# UNITED STATES PATENT AND TRADEMARK OFFICE

APPLICATION NO.	FILING DATE	FIRST NAMED INVENTOR	ATTORNEY DOCKET NO.	CONFIRMATION NO.
10/589,252	08/11/2006	Anders Edgren	PD53612US01	6926

<b>Office Action Summary</b>	<b>Application No.</b>	<b>Applicant(s)</b>	
	10/589,252	EDGREN, ANDERS	
	<b>Examiner</b>	<b>Art Unit</b>	
	TAN TRINH	2618

## **DETAILED ACTION**

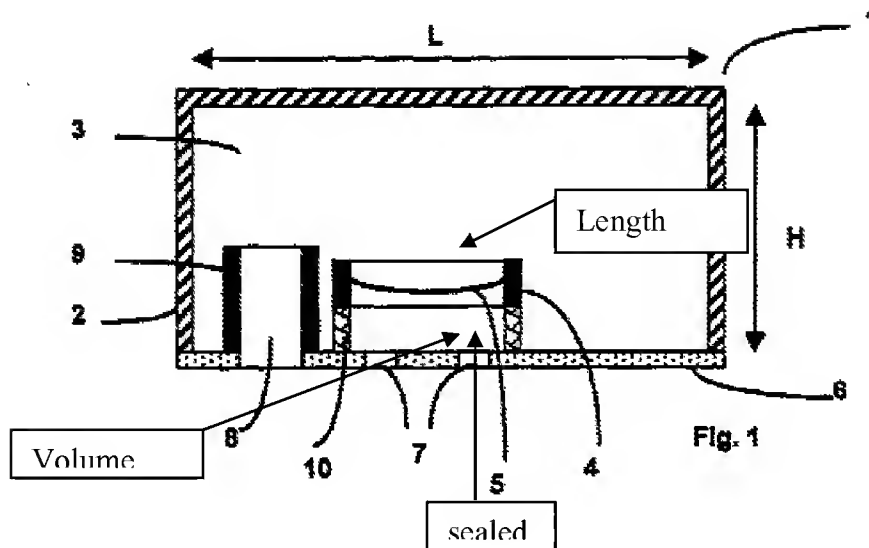
Regarding claim 5, Dufosse inherently teaches the volume (3) of the housing is of the order of between 0.5 and 10 cubic centimeters ( $\text{cm}^3$ ), the length (L) of the acoustic port of the order of between 0.5 and 20 centimeters (cm) and the cross-sectional area (A) of the acoustic port of the order of between 1 and 120 square millimeters ( $\text{mm}^2$ ) (see fig. 1, page 2, sections [0036-0039]).

Applicant argues that the reference of Dufosse does not teach the housing of acoustic of driver (4) is not sealed and is not show the volume and the length in the wall defining an internal, and the desired frequency characteristics does not increase of the high-frequency performance however, the examiner does not agree, Since the of Dufosse teaches the housing of acoustic of driver (4) is sealed and the housing defined by the wall is tightly sealed (10) and that the volume (sealed 10) see fig. 1, page 2, section [0036]). In this case, the volume is the sealed area 10, and the length of the volume is equal to the length of driver (4) (see fig. 1), and the first aperture (7) and the wall (6), this dimension is less than the average width of the human ear and thus enables a user to place their ear over the apertures (7), the sound quality perceived by the user is improved even in discreet earpiece mode. That is obvious to the frequency characteristics comprise an increase of high-frequency performance level relative to a performance of a communications unit alone. (see attached fig. 1 below to show the volume and sealed area).
